Th14a

Prepared March 22, 2012 (for April 12, 2012 Hearing)

From: Madeline Cavalieri, District Manager
Daniel Robinson, Coastal Planner

Subject: **Appeal A-3-SLO-11-064 (Lewis Residence).** Appeal by Maria Jaqua, John Carsel, and Carol Baptiste, and John and Sue Black of San Luis Obispo County decision granting a coastal permit with conditions to Dr. Marshall Lewis for demolition of an existing 2,810 square-foot, one-story single-family dwelling (SFD) and construction of a new 4,555 square-foot, two-story SFD with a 2,377 square-foot underground garage, and relocation of an historic water tank on site, at 709 Lucerne Road in the Cayucos area of San Luis Obispo County. Appeal Filed: September 19, 2011. 49th Day: Waived.

Historical Bluff Erosion
And Undermining

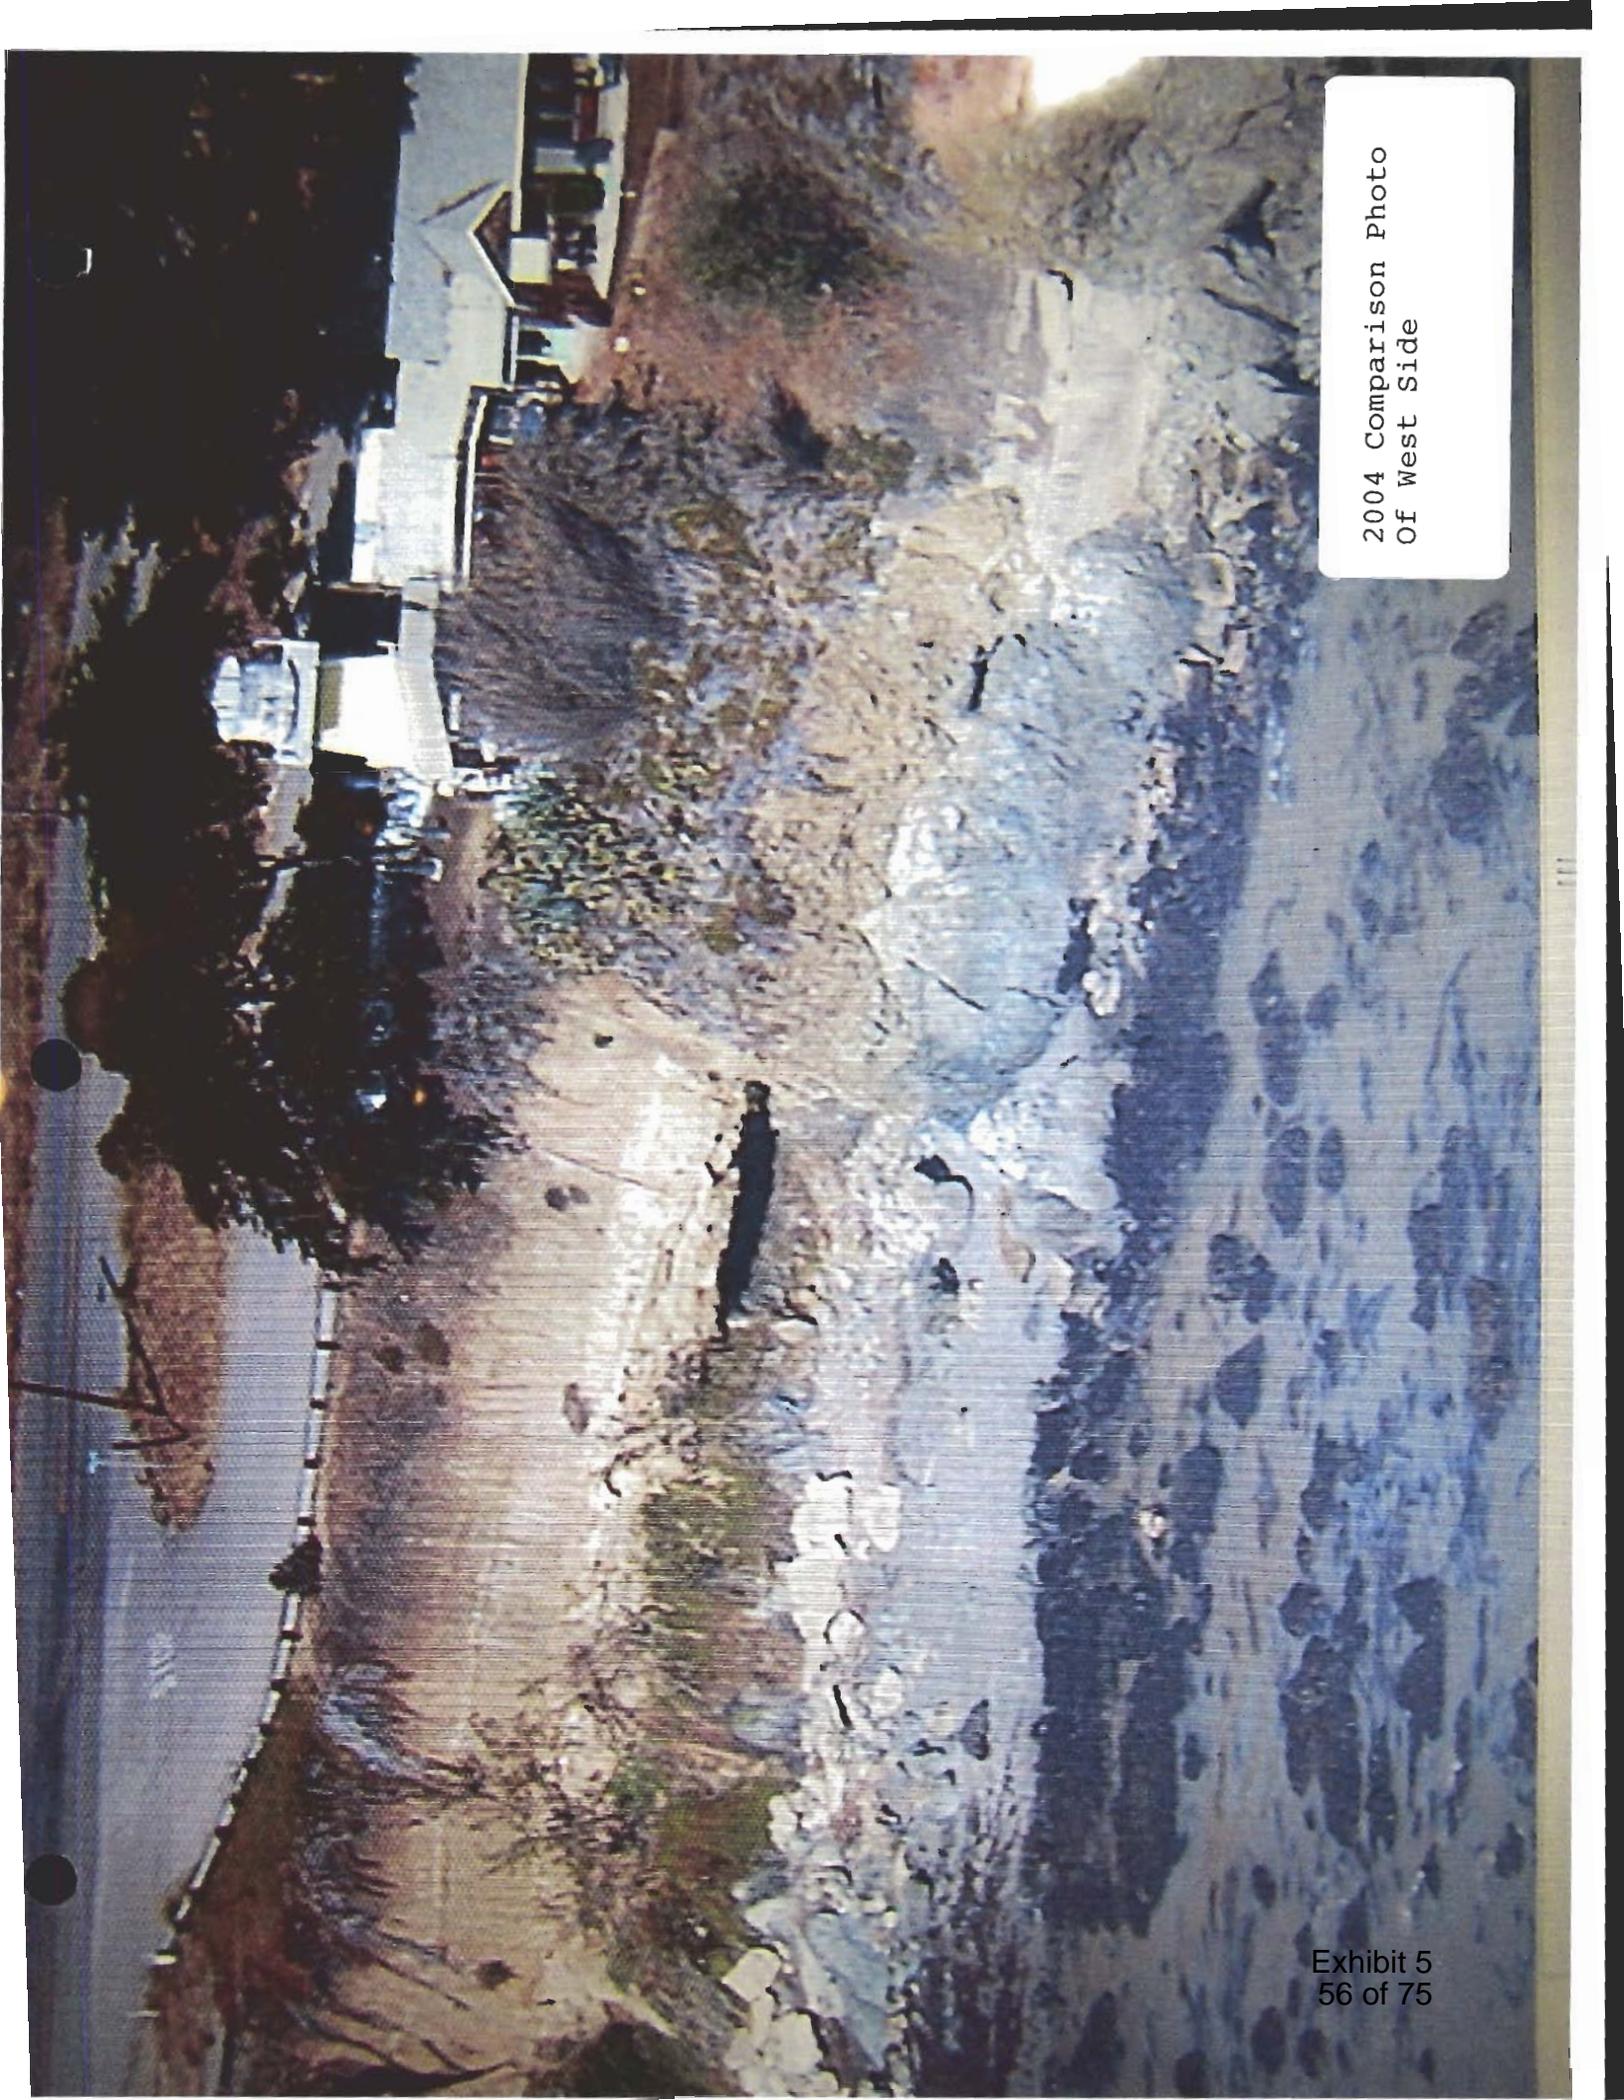
We believe that the proposed basement excavation will be in the area of extreme and **ongoing bluff erosion and undermining**, which we feel **were not adequately addressed** in the applicants geological report. The applicant's own geologist, GeoSolutions, in it's January 26, 2011 review of the project (**See Exhibit D-1 - Neglect to Supply Requested Geological Information**) even states that "The slope stability analysis indicates that the addition of a basement **"does not appear"** to affect the instability of the bluff" This comment **seems indecisive, and non-concrete.** This information is critical in determining the 100 year erosion factor that is applied to coastal bluff projects to establish coastal bluff setbacks, as well as the relative stability of the bluff itself. **This parcel has a particular history of accelerated erosion** due to instability of the bluffs and wave action during winter storms. (**See Exhibits D-2 through D-8 - Historical Bluff Failures and Undermining**)

residential development, and that the new residential development is set back from the coastal blufftop edge an appropriate distance to adequately minimize hazards to life and property under the LCP. Specifically, the new residential development is set back 40 feet on the western side and 30 feet on the eastern side from the blufftop edge (see approved project plans in Exhibit 7, pages 68-78).⁴ These setback distances meet LCP requirements.^{5,6}

The Appellants also specifically contend that the project's underground garage would lead to further bluff instability and erosion, and that a nearby spring was not appropriately addressed in terms of geologic impacts. The Applicant's geotechnical consultants prepared a report that addresses these issues, concluding that the basement does not negatively affect bluff stability and that potential impacts associated with the spring have been appropriately addressed.⁷ With respect to the latter, although groundwater was not found within the area of the garage (proposed to a depth of 11 feet below land surface), the presence of groundwater was modeled through a formal slope stability analysis at between 2 and 4 feet above the Franciscan bedrock (encountered approximately 22 to 25.5 feet below the ground surface) as a conservative element incorporated into the stability modeling. This analysis was part of the information used to develop the above-described setbacks, and it appears to have adequately addressed the spring/groundwater issue (see Exhibit 4 and Exhibit 7 pages 120-131). In addition, the Commission's senior geologist, Dr. Mark Johnson,⁸ has reviewed the relevant reports and concurred that it is likely that the majority of groundwater flow in this situation, as is commonly the case in this region, is through the marine terrace deposits lying on top of the bedrock layer. Plans show that the garage is not extending into the bedrock, leaving approximately 13 feet of marine terrace deposits intact, and thus that it is unlikely to affect groundwater flow, bluff stability and erosion at this location.⁹ In addition, the County attached conditions to appropriately address stability, excavation, and groundwater issues, including requirements for: a drainage plan (to be prepared by a registered civil engineer); a sedimentation and erosion plan; an on-site engineering geologist to monitor the site during excavation; and appropriate construction materials designed to retain earth and waterproof the development, all designed to help ensure bluff integrity throughout construction and after completion.
